Subject Subdivision Amendment: Elizabeth Johnson Subdivision

Subject: Peer Review for Preliminary Major Subdivision Amendment Application

Land for Elizabeth Johnson,

104 Foreside Rd, Cumberland-Foreside ME 04110

SHEET CT

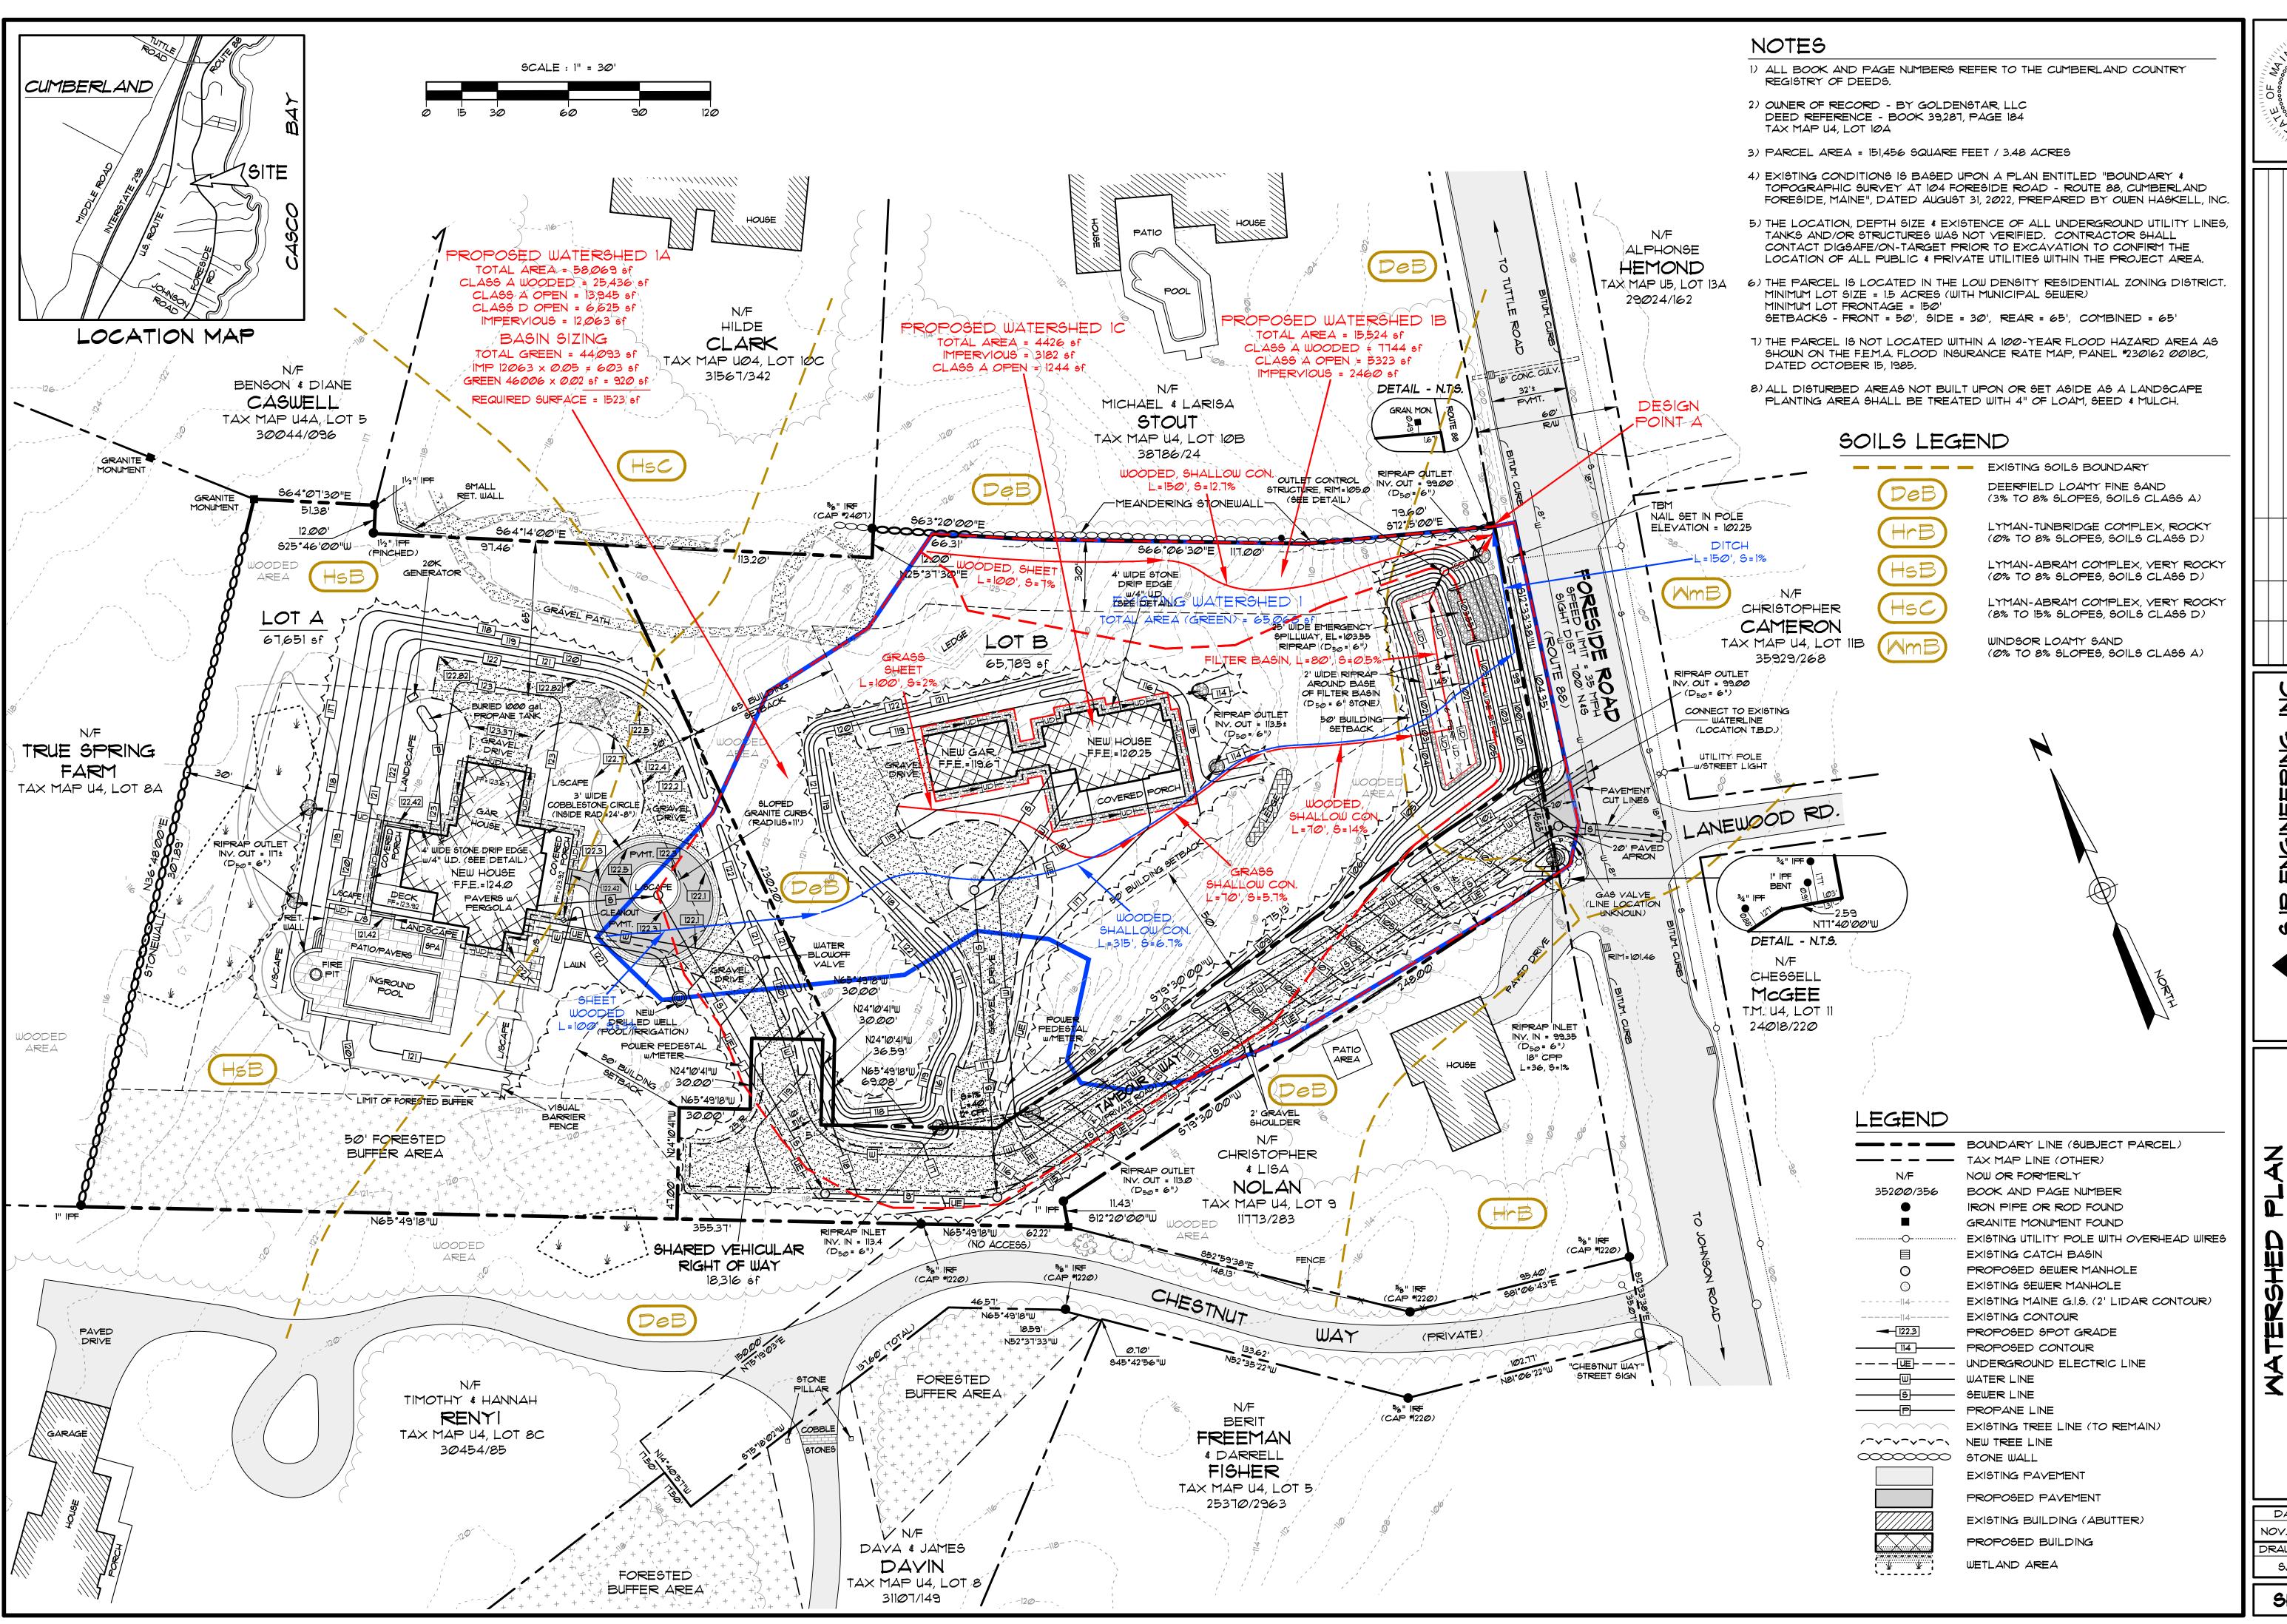
- 13. Plan Sheet C-20 Please confirm that a transformer is on the pole or provide a pad-mounted transformer to service the two new lots.
- 14. Plan Sheet C-7 Grading and Drainage Plan Please replace the 12-inch culvert at the driveway entrance with a minimum 15-inch culvert to minimize clogging and per the Town's Street Construction Standards. Please confirm cover and clearances with the sewer line in your response.

- 15. Plan Sheet C-7 Grading and Drainage Plan Please provide sizing and invert in and out elevations on the culvert at the roadway entrance with a minimum 15-inch culvert. Please confirm cover and clearances with the sewer line and water line in your response.
